AMENDMENT NO. 1

IFB GHURA-26-009 Modernization of Fiscal and Mod Office

This Amendment No. 1 is hereby issued to amend the Bid Submittal requirements for the above referenced Invitation for Bid (IFB).

2ND OFFICE FLOOR PLAN

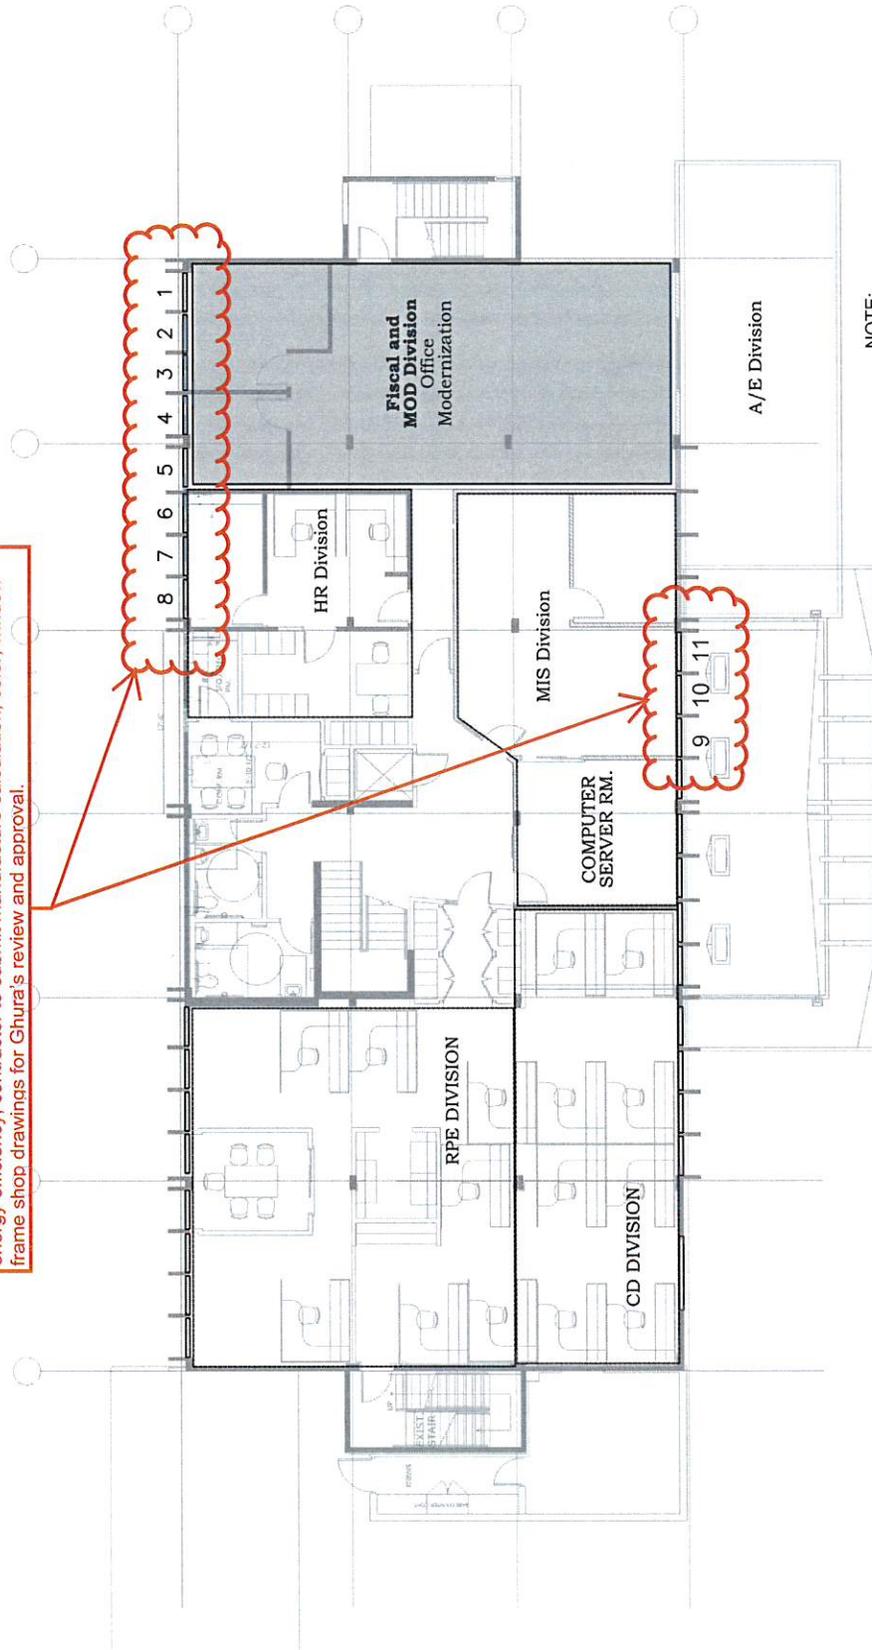
Please see attached revised 2nd Office Floor Plan

Existing windows to be removed and disposed. Provide new aluminum sliding glazed window panels (both panels sliding) with aluminum accordance storm shutters. New windows and storm shutters shall withstand 195mph wind force. Work to include latch lock mechanism, anchor bolts. Windows shall be tinted for energy efficiency, contractor to submit manufacture calculation, color, window frame shop drawings for Ghura's review and approval.

NOTE:
Contractor shall field verify existing WINDOWS condition and dimensions prior to bidding. Contractor to notify contracting officer for any discrepancies between scope of work, actual field conditions and project intent which may interfere with this project. typical.
